**Response to Submissions  
Received on Application  
ABP Ref. 320938**

Woodquay Park  
Enhancement

Project Number: **230108**

Figure 1: Comparison of soft landscaping areas on each design proposal.

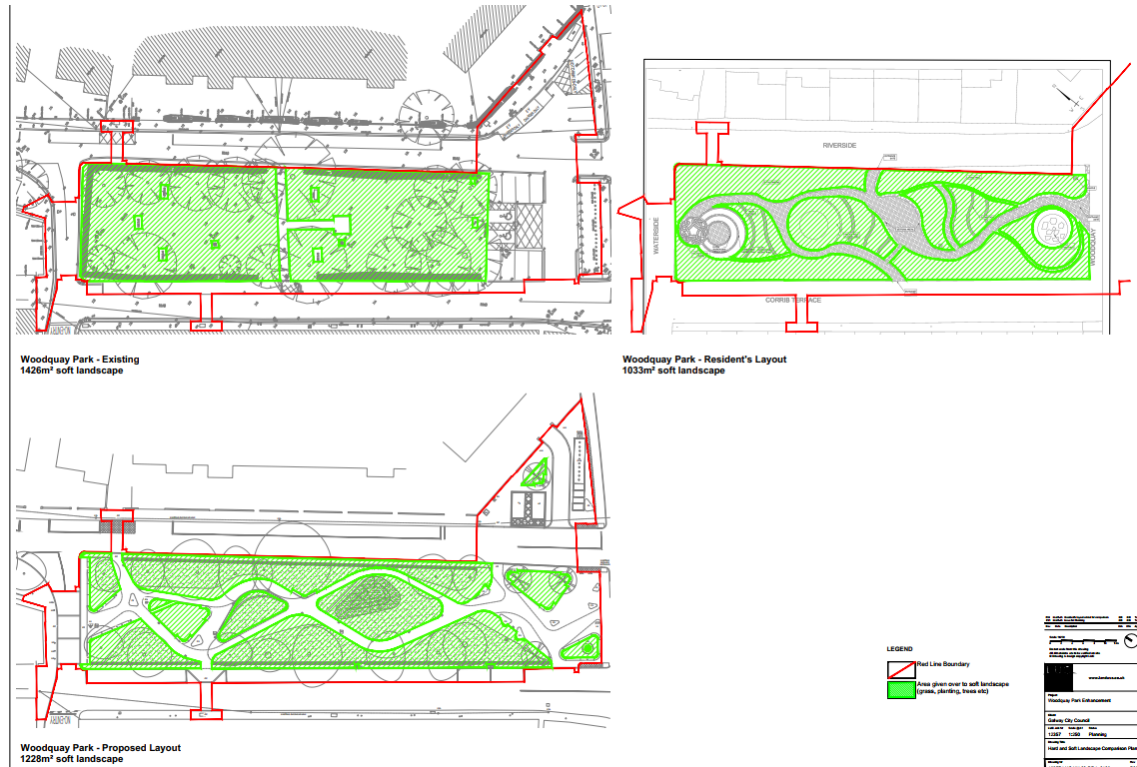
During the consultation events, it was discussed that while the proposed development does provide marginally less soft/green landscape areas than exists currently, the proposed green areas are of a higher quality, providing enhanced amenity and additional habitats for local flora and fauna, along with sustainable urban drainage. The enhancements will include pollinator friendly bulb planting, rain garden planting, *Molinia* meadow planting, ground cover planting, and amenity grass planting which will increase ecological diversity within the site. Stemming from this enhancement, the design has proposed an accessible footpath route that encourages exploration of the park, and the nature contained within it, rather than a straight ‘A to B’ route. It is highlighted to the consultees that the designing of the footpaths to be universally accessible and providing enhanced connectivity to spaces the park (including for the mobility impaired), has resulted in the overall reduction in soft/green landscaping.

While it is understood that there is some disappointment that the Mary Reynolds’ proposal was not used in its entirety or more extensively, it should be acknowledged that this proposal set out considerably less soft landscape than this proposed development (see **Figure 1**, also included in full resolution in **Appendix 1**). It should also be noted that the path widths shown in the Mary Reynolds layout often do not meet universal accessibility criteria and therefore are not practically implementable. Should the

Mary Reynold's design have been used, enhancements to bring the footpaths into line with universal accessibility standards would have further reduced the provision of green space while also significantly impacting the design quality of the space. We also wish to highlight that universal accessibility was one of the strongest requests of the residents at the previous consultation events and is something that has strongly impacted the design of the park. Overall, it is submitted that the proposed development achieves a high quantum of soft landscaping whilst providing high quality accessibility.

Figure 2: Grant of Permission for GCC Pln. Ref. 11/154, extracted from Mr. Robert Grealish's observation.

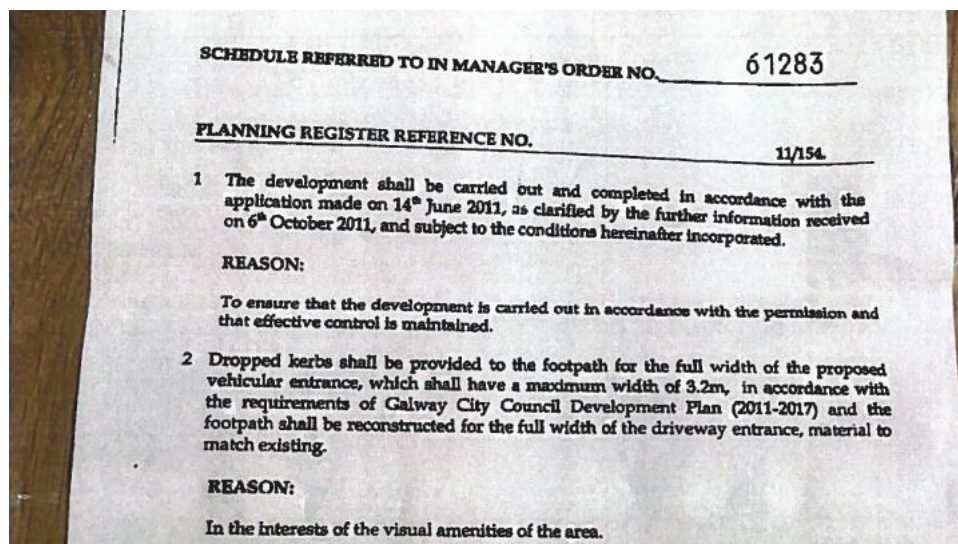
The respondent raises concerns regarding vehicular access to their property, stating that *"the proposed access road should, at the very least, exceed this fixed opening of 3.2 metres and should be constructed to the industry standard of 3.6 metres (12 feet)"*. He also raises that the planning permission for his property sets out required the width of the access point. First, we wish to note that the width of the access to 8 Walsh's Terrace is 3.15m under the proposed development. The planning permission for the property prescribes that the access road should have a maximum width of 3.2m in Condition 2 of the grant of planning permission (GCC Ref. 11/154), as shown in **Figure 2** below. Therefore, there is no conflict between the proposed design of Woodquay Park, and the permitted width of the respondent's driveway.

Further to this, there is no requirement for a standard of 3.6m width for site accesses within DMURS, which is the appropriate road design guidance document for the subject site. We wish to note that **Section 4.4.1: Carriageway Widths of DMURS** states *"Research from the UK has found that narrow carriageways are one of the most effective design measures that calm traffic."* Therefore, it is not considered appropriate to widen a site access which has functioned well for over 10 years, in an area where calmed traffic is desired. As a result, we request that this request is dismissed by the Board.

Figure 3: Proposed layout of Woodquay Park with markings indicating the location of Mr. Croghan's residence and the new crossing he has expressed concerns with.

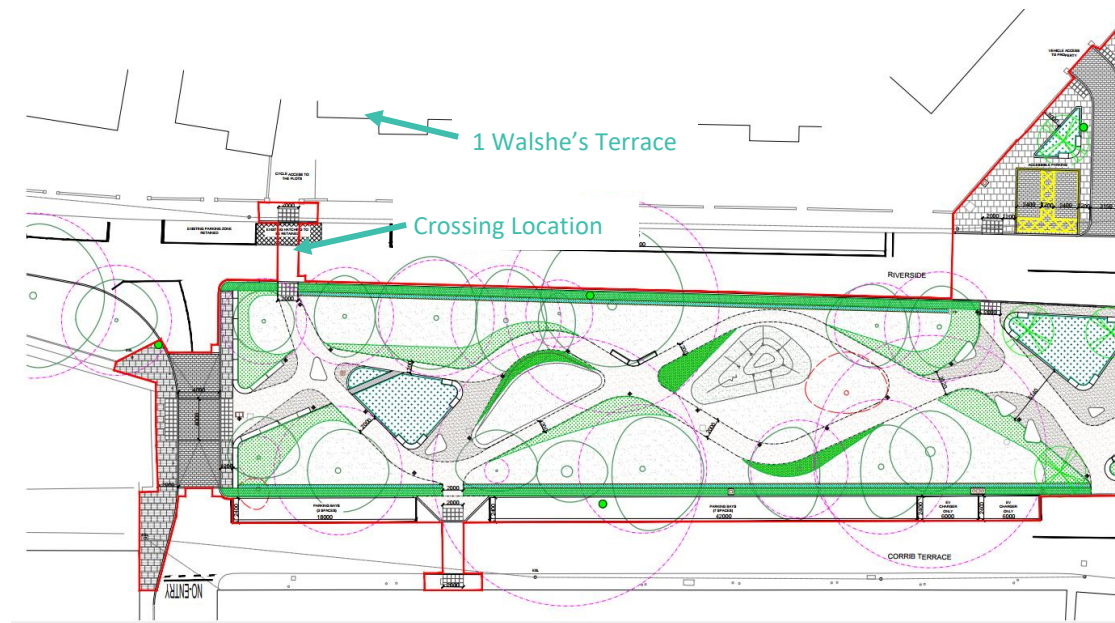
Mr. Croghan has raised concerns that the proposed new entrance to Woodquay Park could reduce the residential amenity of his home and represents a reduction in privacy. We firmly reject this assertion and raise that the proposed entrance does not materially alter the existing privacy of the site. First, we highlight that the proposed new entrance to the park and pedestrian crossing of Riverside aligns with the overall upgrade plan and enhances public accessibility. This linkage is already functioning as an active travel route, and is therefore expected to be used by cyclists, and pedestrians. **The crossing serves a critical active travel desire line from the Plotts into Woodquay Park, providing a safer crossing and overall road layout.**

pattern, the claim that the pedestrian crossing would encourage more people to look into the consultee's home is unsubstantiated. Therefore, the claim of a "significant reduction in privacy" is subjective given the existing use and character of the area, and does not constitute grounds for rejecting or modifying the proposal.

We wish to note that concerns regarding residential privacy have been carefully considered throughout the iterative design process. It is important to highlight that buildings which face public spaces (e.g. roads, parks, or pathways) inherently experience some level of visibility from passersby – and the public spaces experience positive overlooking from these properties. The concerns regarding residential amenity were noted throughout the public consultations, however, precedent of providing similar crossings elsewhere in Galway and Ireland has not been shown to increase loitering at the crossing point.
